Technical Note 01

Project:	Wensley Road, Reading	Office:	Southampton
Project No:	A115865	Prepared by:	GS
Client:	Reading Borough Council	Approved by:	SW
Date:	July 2020	Status:	For Information
Subject:	Transport Statement - Addendum

Figure 2.1 Revised Swept Path Analysis

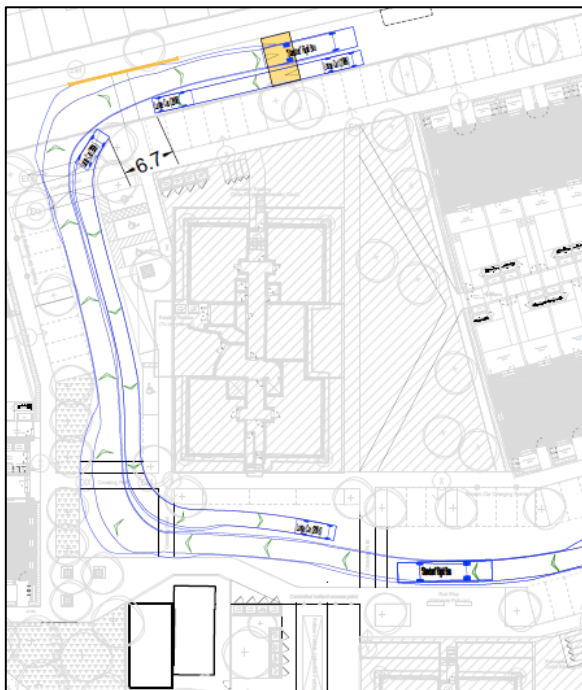
- 2.1 The LHA stated that the swept path analysis of the bus and an oncoming car showed that there was not sufficient space between the vehicles to pass on the 90 degree bend located within the site.
- 2.2 As a result, the geometry of the carriageway has been altered to provide a wider kerb line, which allows the vehicles to pass. The swept path analysis is illustrated on **Figure 2.1** below, with the full drawing included as on **Drawing A115865-SPA08 Rev G** at **Appendix B**.

- 2.3 The raised surface has been omitted in this central area to facilitate bus movements. Instead, contrasting paving is proposed in this area.
- 2.4 The south-eastern crossing point shown on **Figure 2.1** has been moved to avoid conflicting with emergency vehicle access.
- 2.5 At the south-eastern junction, the raised table previously proposed has been omitted, in line with comments by the LHA, as shown on **Figure 2.2**, with a crossing added in its place.

Figure 3.1 Swept Path Analysis of Western Road

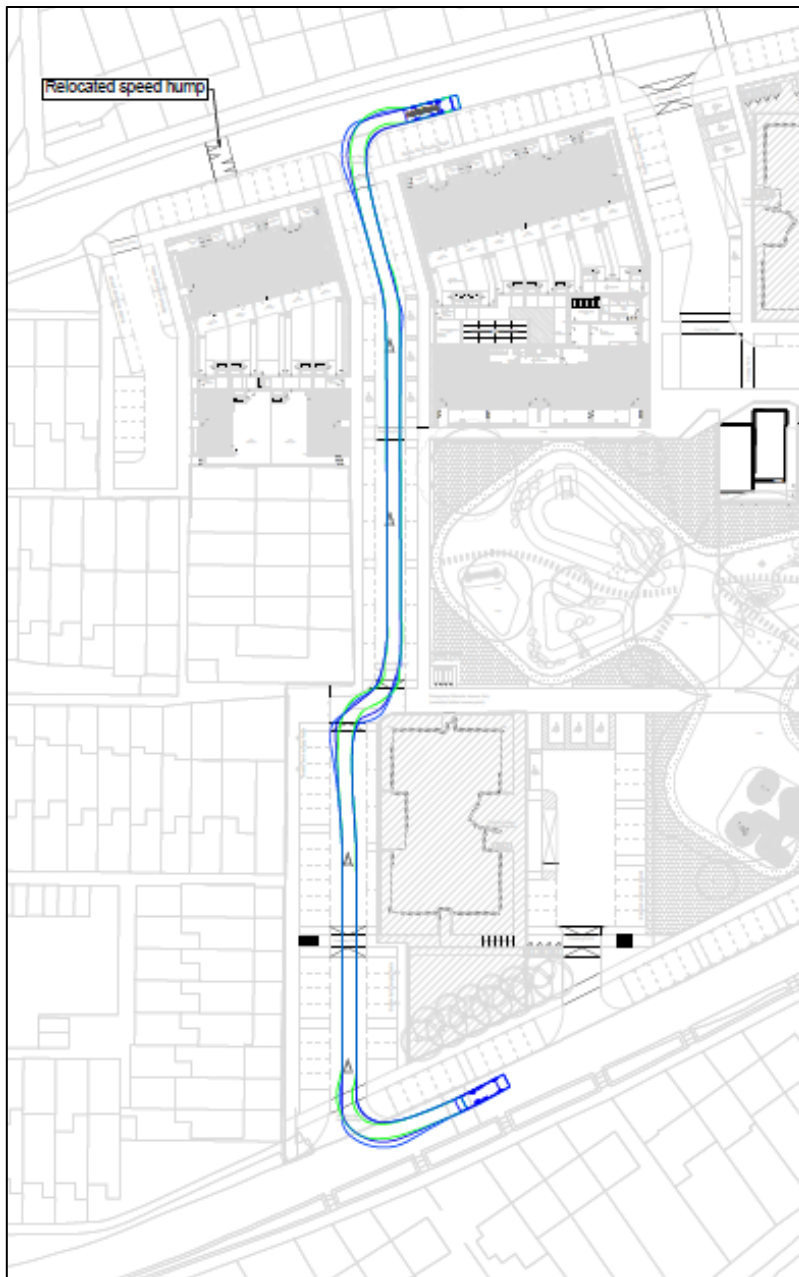
- 3.1 Following comments by the LHA, the western access road running north to south through the site has been reconfigured to be a one-way route, from north to south. Amendments have also been made to the crossing points, with a raised crossing and give way markings located at the central crossing point, and dropped kerbs and tactile paving at the northern crossing point.
- 3.2 The raised table that was previously proposed between the two crossing points has been omitted.
- 3.3 A swept path analysis of the western road is shown on **Drawing A115865-SPA07 Rev E** at **Appendix B** and illustrated on **Figure 3.1**.

Proposed Site Plan

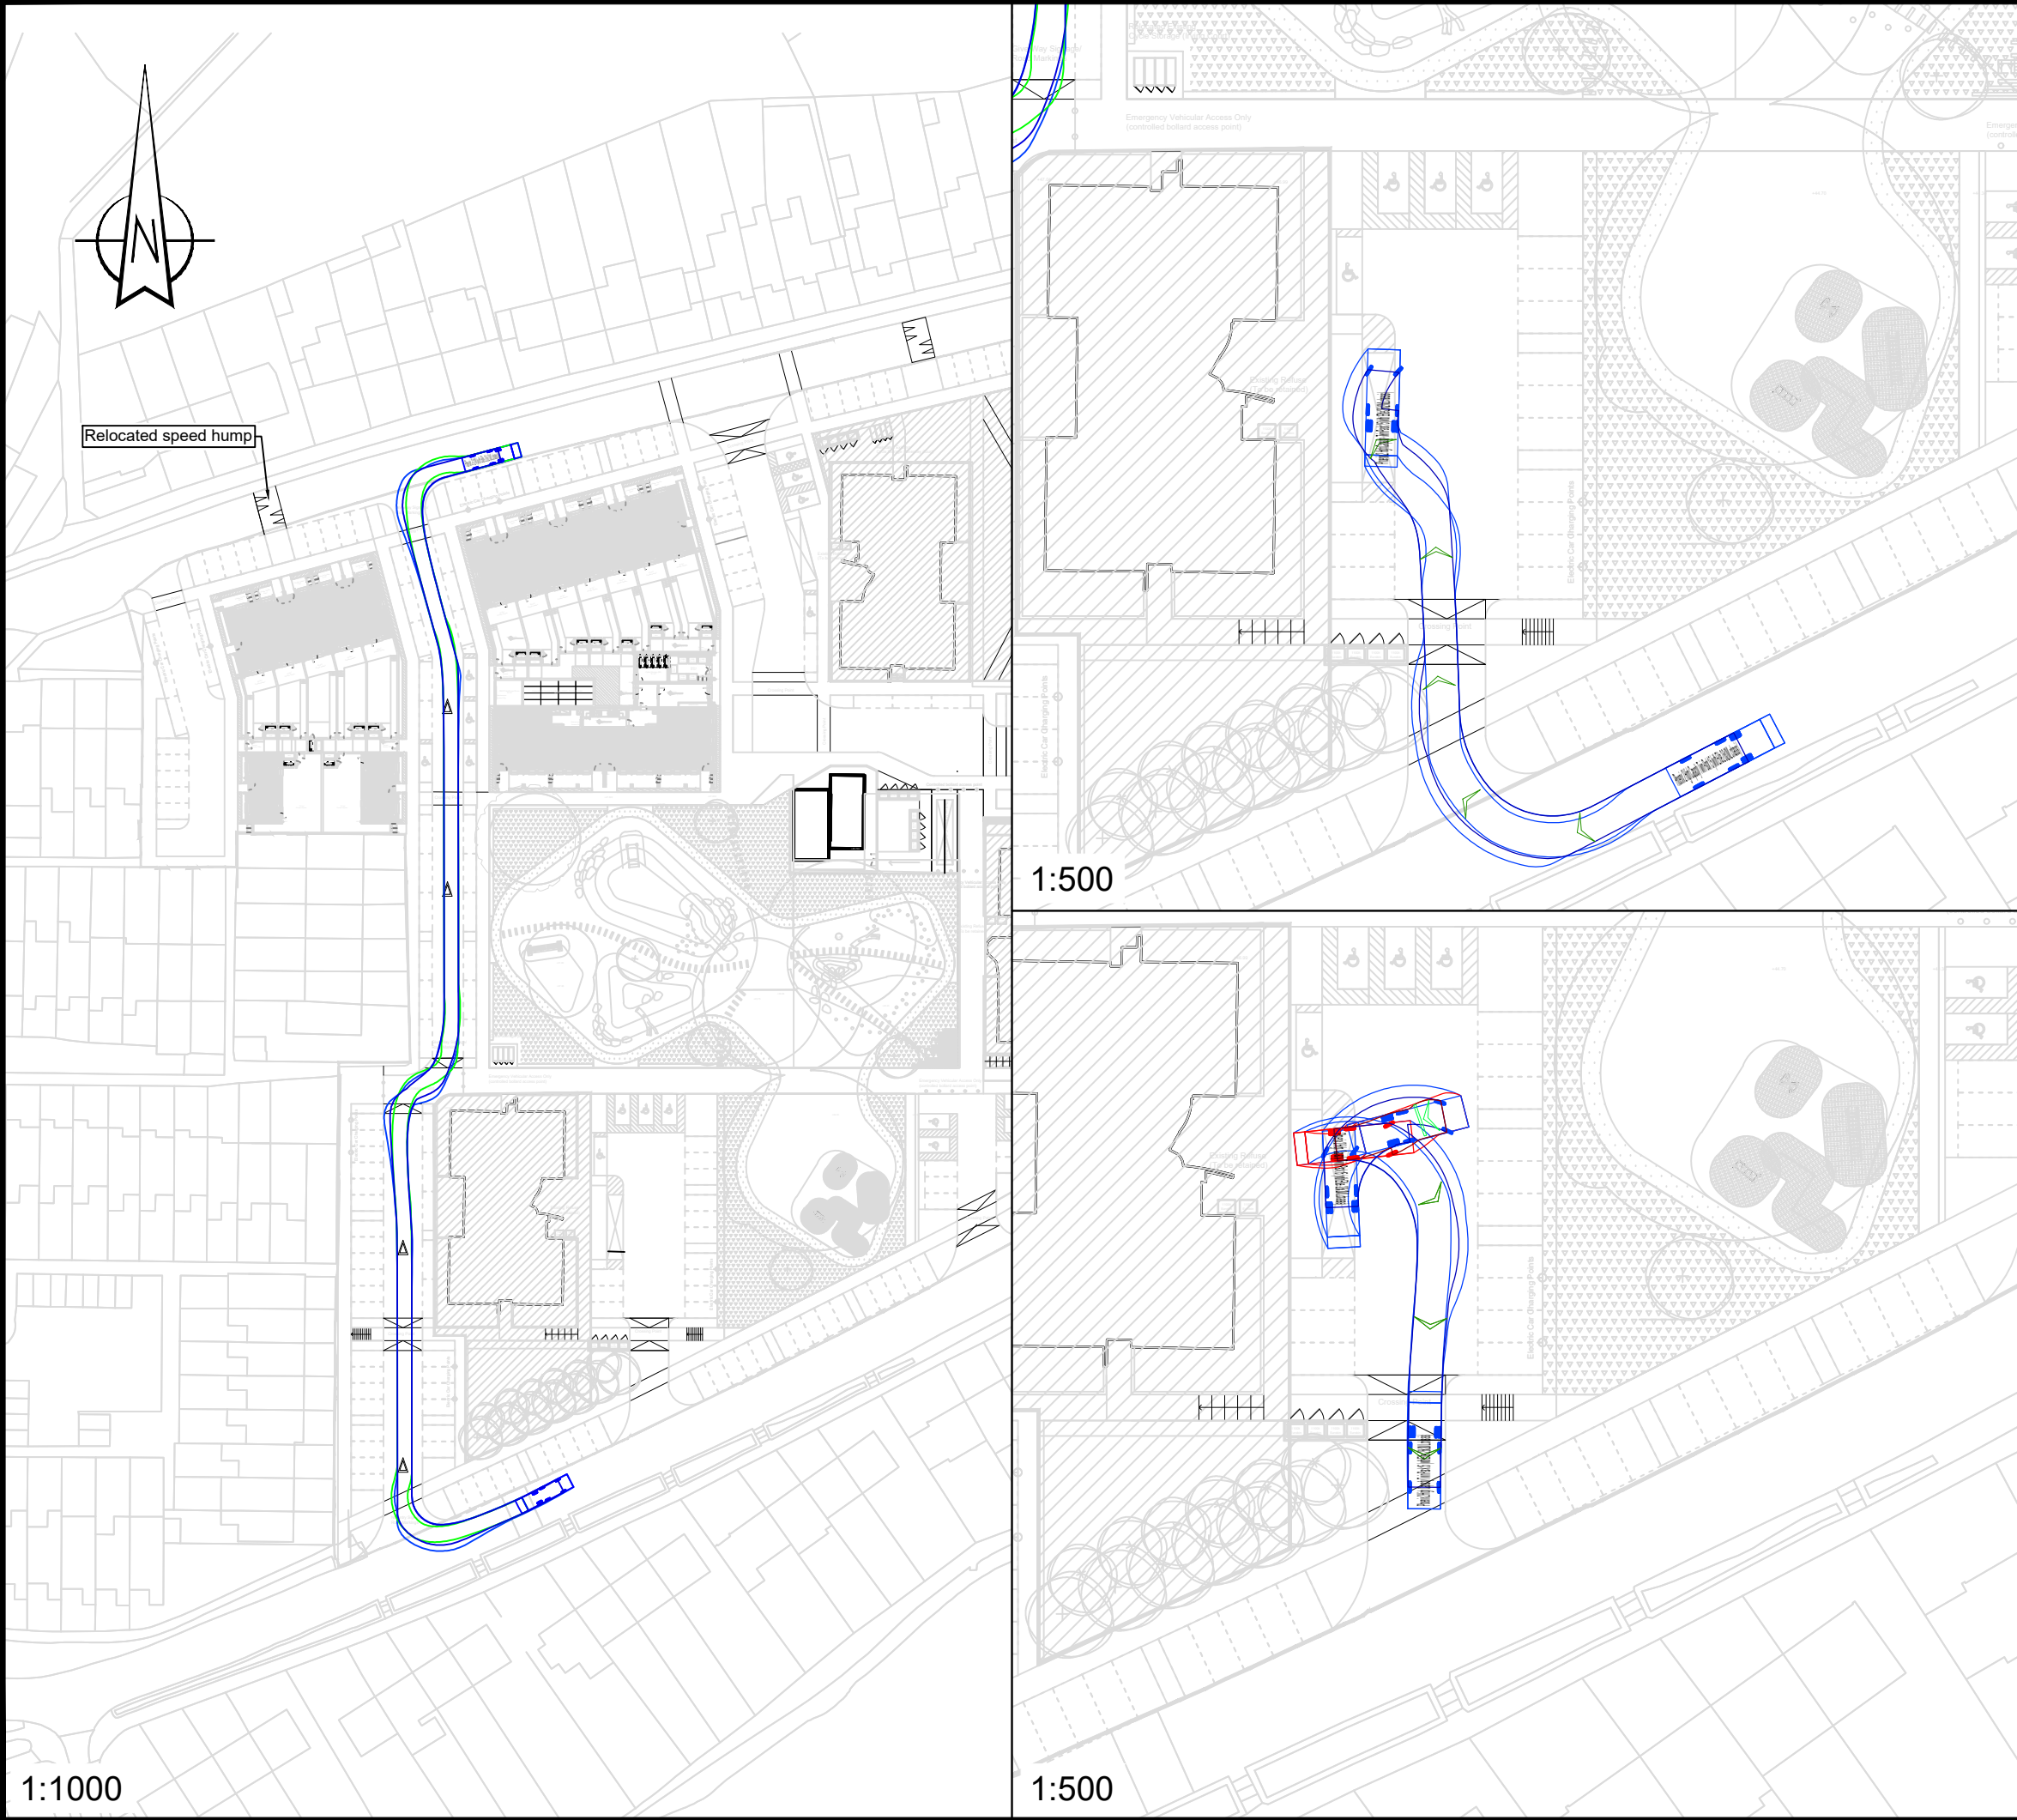
- 1.1 WYG has been commissioned by Reading Borough Council (the 'Applicant') to prepare a Transport Statement (TS) to support a proposed residential development at Wensley Road, Reading (the 'site').
- 1.2 The planning application (ref. 200122) was submitted in January 2020. This Technical Note addresses the issues raised by the Local Highway Authority (LHA) in response to the proposals. A revised site layout is included as **Appendix A**.
